**BC BUILDING CODE INTERPRETATION COMMITTEE
AIBC, APEGBC, BOABC, POABC**

File No: 98-0157	INTERPRETATION	Page 1 of 1
Interpretation Date:	November 21, 2006	
Building Code Edition:	BC Building Code 1998	
Subject:	Parking garage vestibule	
Keywords:	Vestibule, storage garage	
Building Code Reference(s):	3.3.5.4.(1).

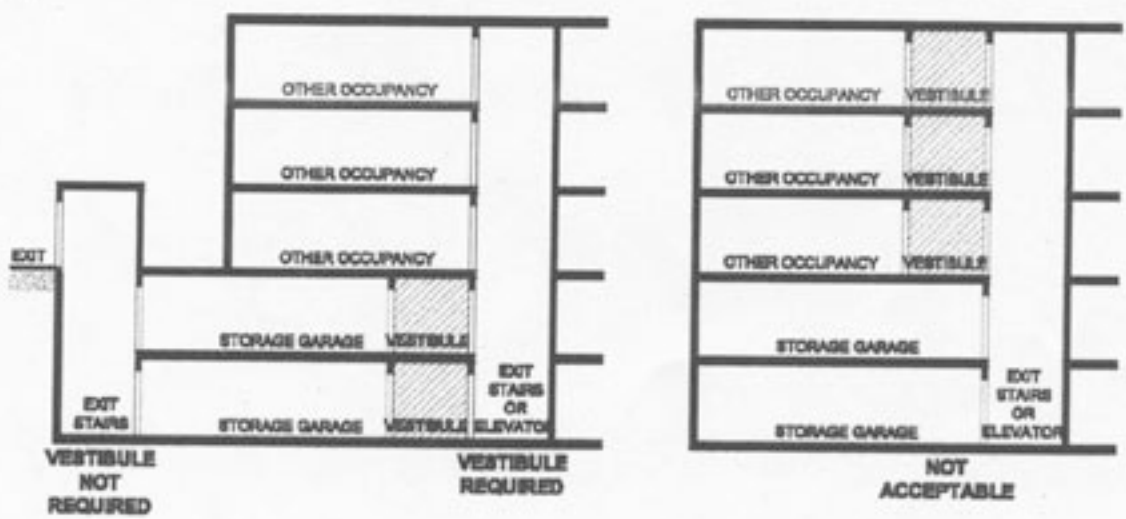
Can an access from storage garage to other occupancies above be provided with the vestibules located at the floors above storage garage instead of vestibule between storage garage and stair tower or elevator?

No.

Sentence 3.3.5.4.(1). clearly defines the location of the required vestibule is between storage garage and stairs or elevator and not between the stair or elevator and the occupancies above.

Provision of the vestibule at the storage garage level is a correct measure to limit ingress of carbon monoxide and other exhausts from the storage garage to the stair tower or elevator serving other occupancies.
